Exhibit 2

Declaration by Ben Levi and Paul Héroux In regard to the SpaceX Starlink™ network

Purpose: The purpose of this declaration is to point out deficiencies in the Radiation Hazard Report filed by Space X in support of the FCC's Radio Station Authorization and support an Environmental Assessment of the whole satellite/ground station program.

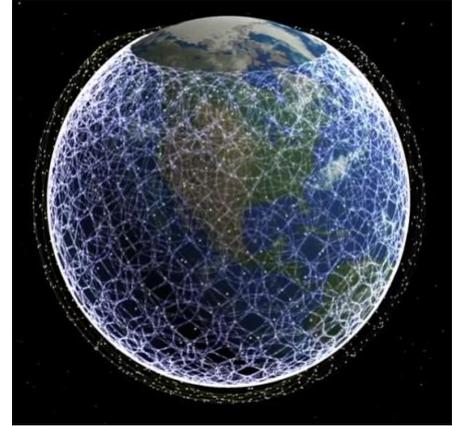
As stated in the Application for Expedited Review, notwithstanding that earth stations and satellites form one wireless infrastructure, the FCC and applicant companies like SpaceX are approaching the program in a piecemeal fashion, seeking approval in each case without any regard to the whole. But as Professor Heroux mentions, the whole planet will be irradiated by thousands of SpaceX and other satellites, each beaming down RFR to many CP terminals and larger base stations in a many-to-many relationship, blanketing the Earth, and every living being on it with RFR. The consequences of this are totally unknown, and have never been modeled publicly, let alone studied. The above image depicts what this RFR blanket may look like.
